工程指示 / 要求簡箋 ENGINEER INSTRUCTIONS(E.I.)

工程指示編號:	EI- 9394	修改版本:	-
	HK- 0015		
工程編號:	J 861	工程名稱:	己連拿利
收件人:	生統/技術部	發件人:	細佬
工程項目:	幕牆施工圖更新	日期:	07/01/2026

PROJECT :
PROPOSED RESIDENTIAL DEVELOPMENT AT NOS. 3-6 GLENEALY, CENTRAL, HONG KONG

DWG NO. : J861-BD-CW-3005 REV. : A

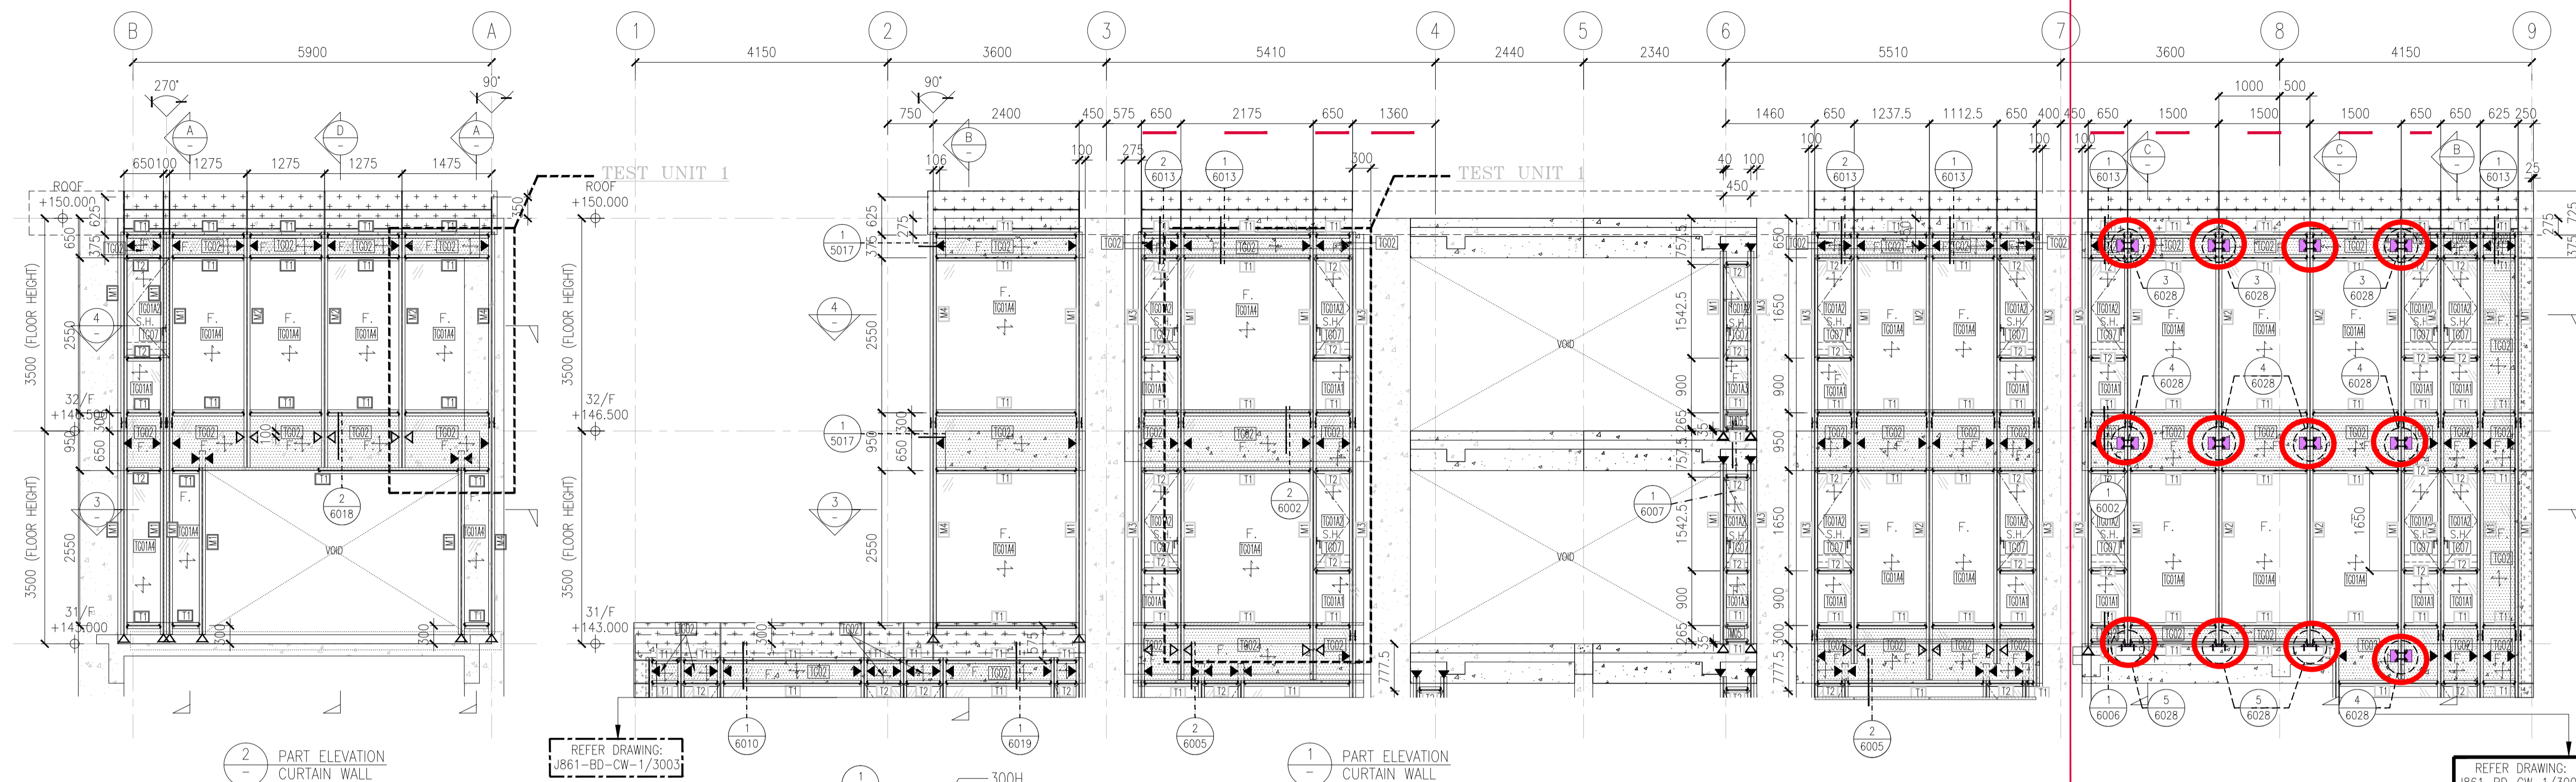
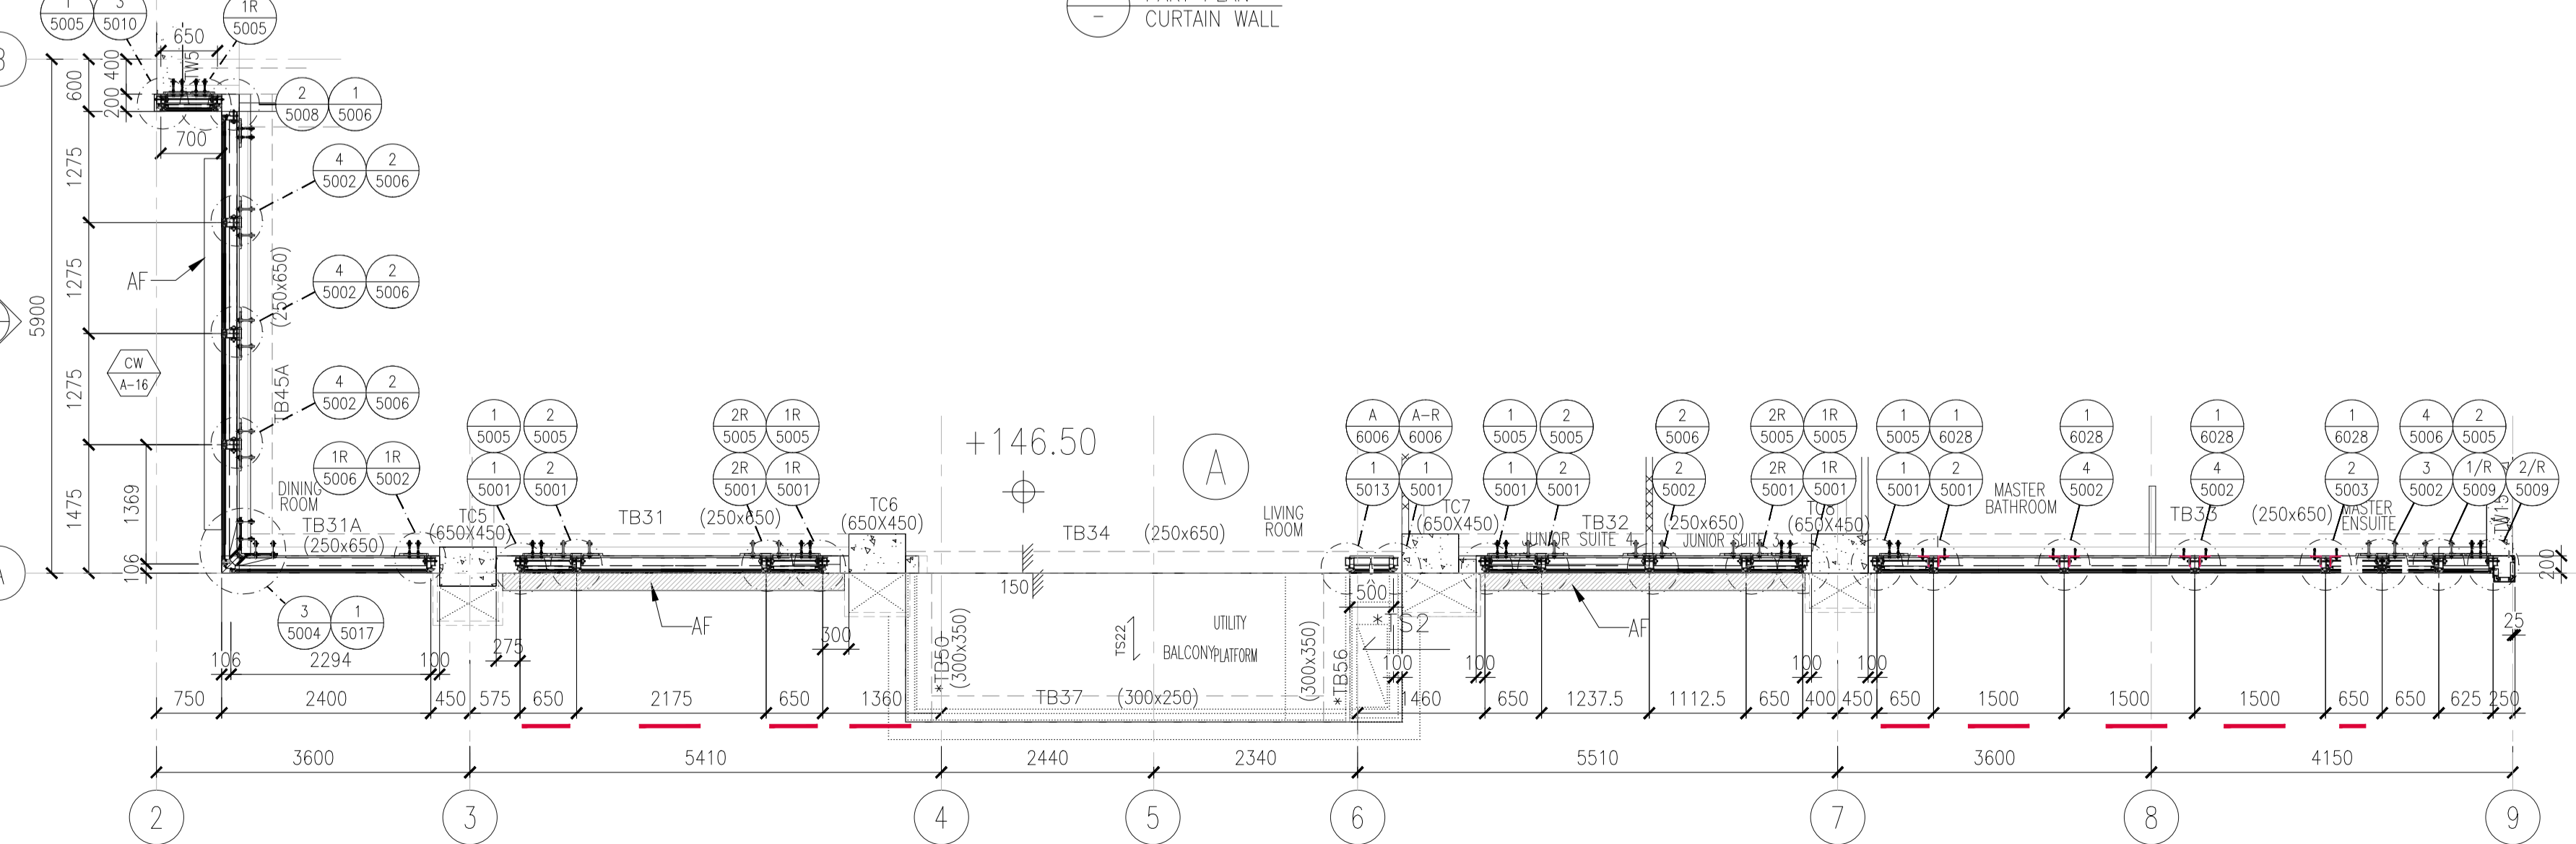
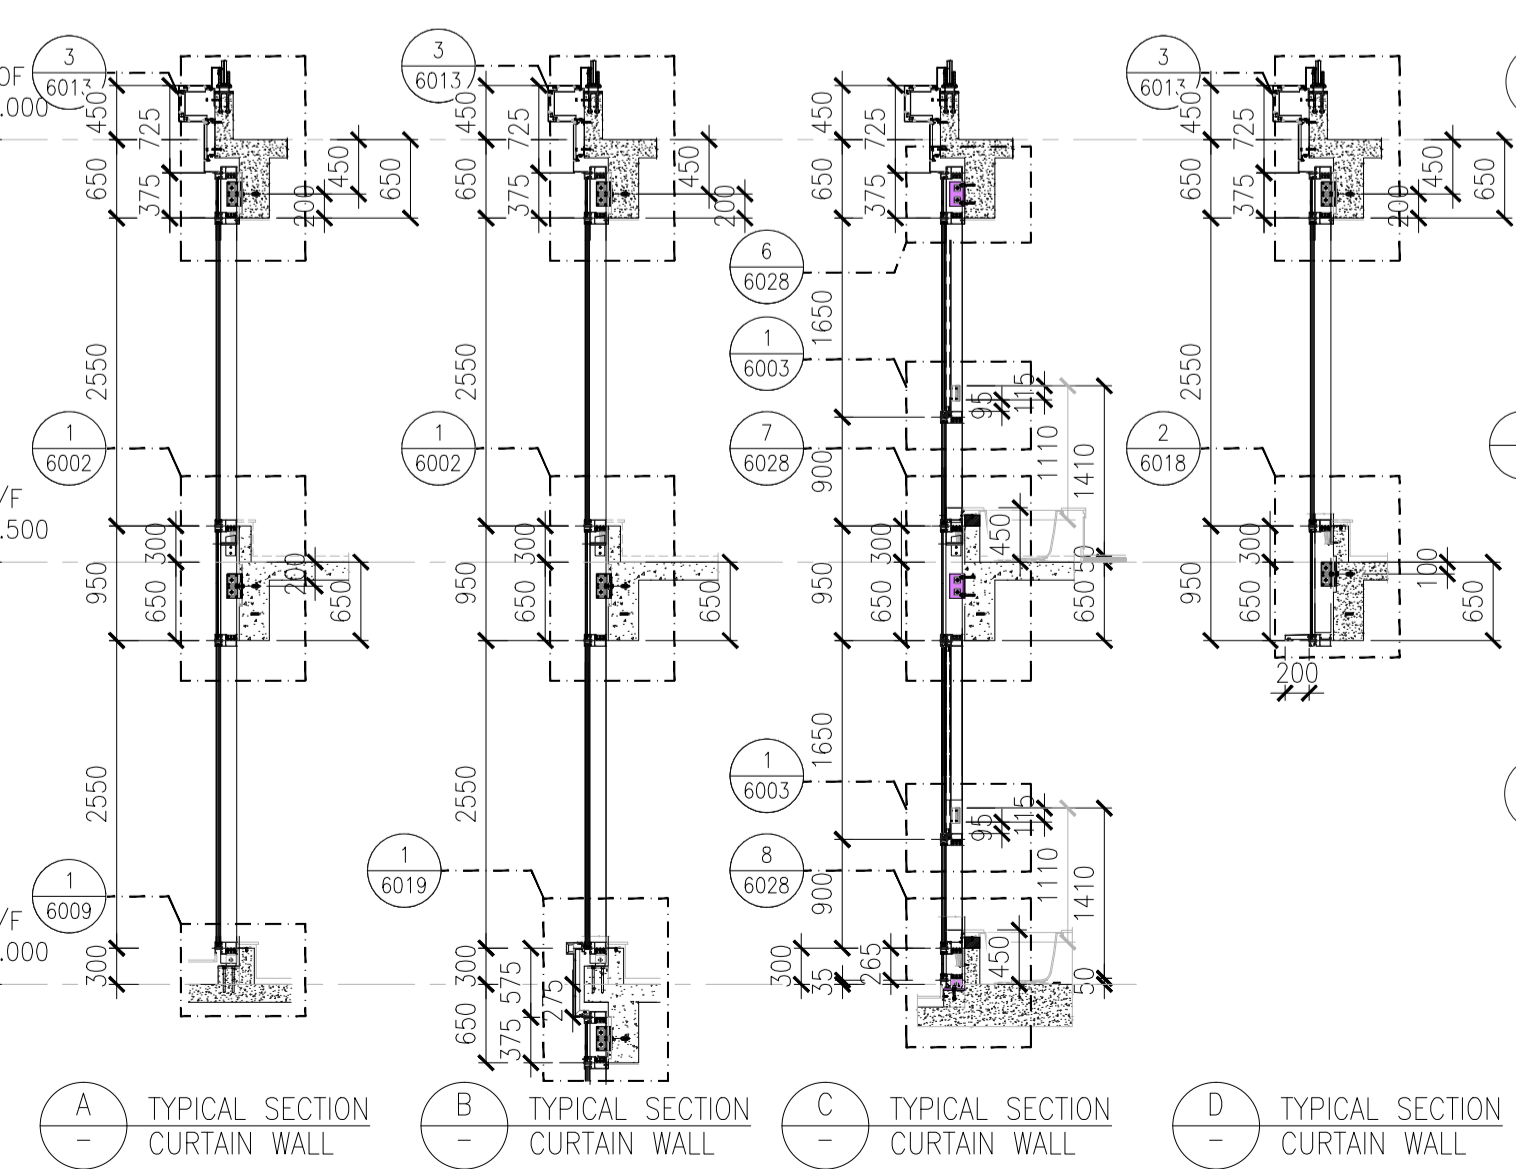
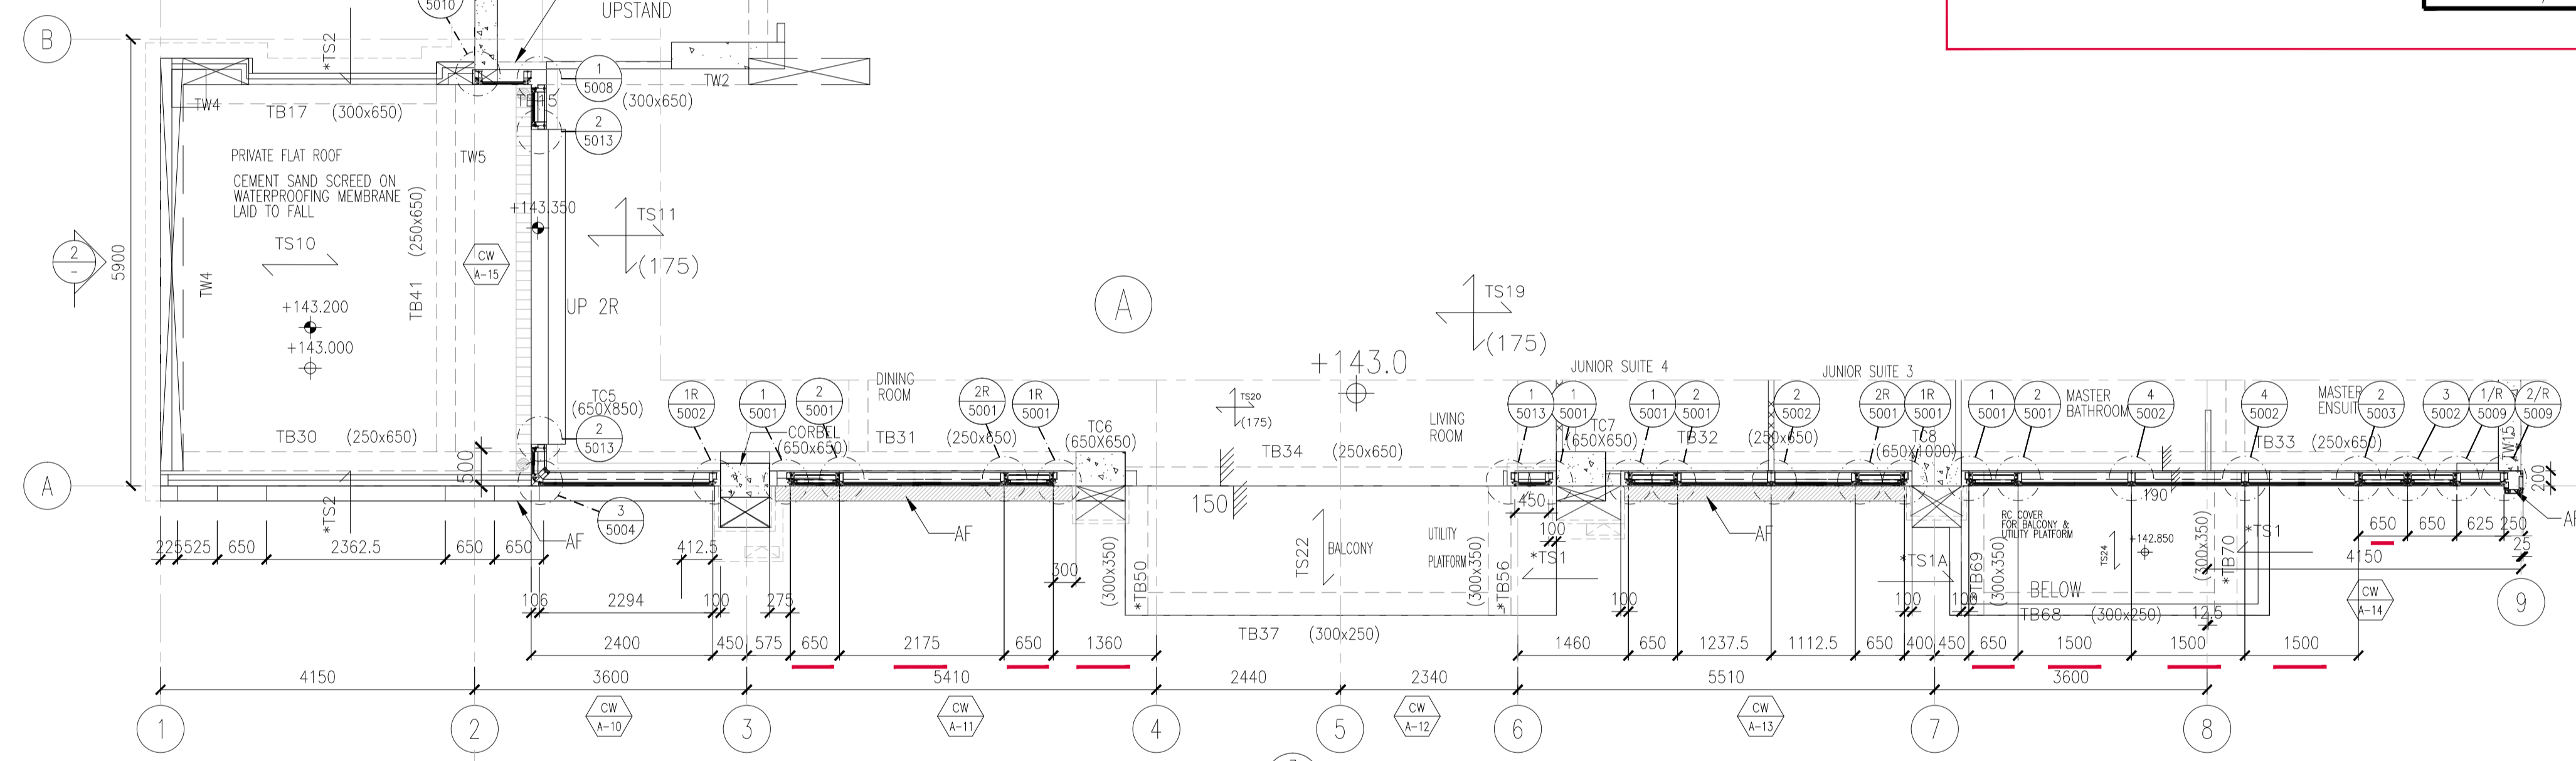
內容:	<p>給技術部: 31和32樓幕牆要打拉爆螺絲的修補方案(請看附頁資料紅圈的位置), 請製作相關的鐵件加工圖。</p> <p>另外圖號: 6008的趟門頂要鐵角設計有改, 需要重新訂料和製作加工圖(紅色圈內的鐵角, 只影響SD-04和SD-04R)</p> <p>備注: 1月6日大明通知</p> <p>CAD文件在以下位置</p> <p>J:\midi_sharepoint\Public\to_china\謝永林\J861\EI9394_HK0015_CAD</p>
完成上列要求日期:	15/01/2026
